World Forum for Harmonization of Vehicle Regulations

Proposal for Amendment 1 to UN Global Technical Regulation No. 13, Phase 2 (Hydrogen and Fuel Cell Vehicles)

Submitted by the Working Party on Passive Safety *

Figure 6

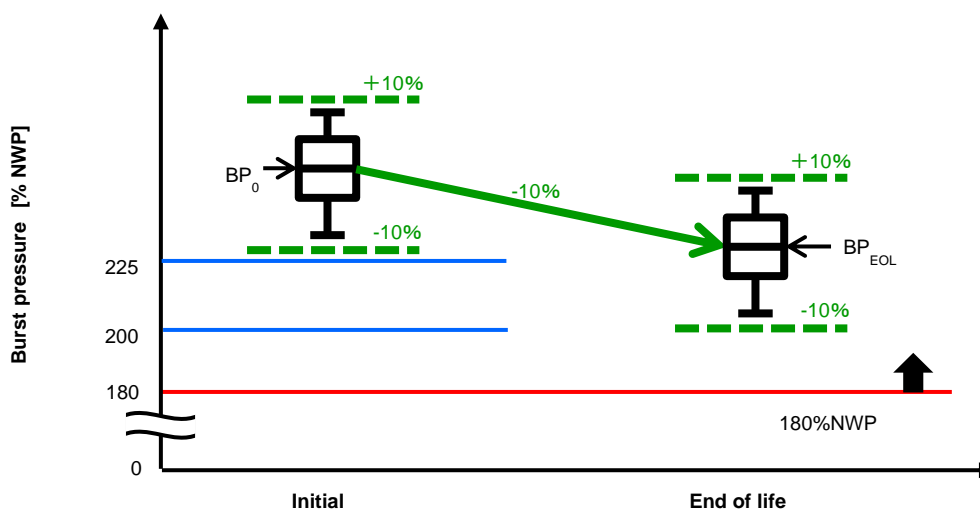
65. In subsequent discussions of Phase 2, Japan presented data from experiments using carbon-fibre composite containers for 70 MPa, to support the minimum initial burst pressure change from 225 per cent NWP to 200 per cent NWP for carbon fibre containers only (Tomioka, J. et al. (2019 September); "Influences of Hydraulic Sequential Tests on the Burst Strength of Type-4 Compressed Hydrogen Containers." 2019 International Conference on Hydrogen Safety. Technical Paper ID 159).

66. The relationship between the current initial burst pressure requirement and the estimated end-of-life burst pressure requirement is shown in Figure 6. The Japanese experiment showed that containers which met the $BP_0 \pm 10$ per cent requirement and subjected to the hydraulic sequential tests, were able to meet end-of-life burst pressure of at least 180 per cent NWP, even if the minimum initial burst pressure is reduced to 200 per cent NWP.

Figure 7
Results from the Verification Test

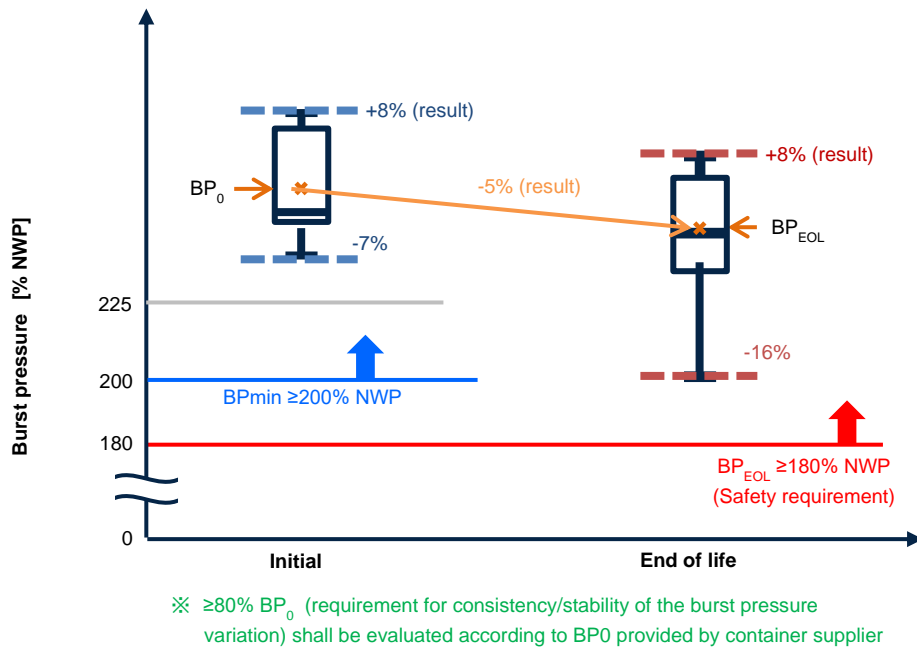
68. The test results are shown in Figure 7. The minimum value of the initial burst pressure was greater than 225 per cent, and within the ± 10 per cent of BP_0 requirement. The end-of-life burst pressure, which takes into account the variation and degradation ratio due to testing, was greater than 180 per cent NWP. It was also greater than 80 per cent of BP_0 by a sufficient margin (Figure 8).

69. The results show that the minimum initial burst pressure of 225 per cent NWP can be reduced to 200 per cent NWP while maintaining end-of-life burst pressure (BP_{EOL}) above 180 per cent NWP and 80 per cent of BP_0 requirements.
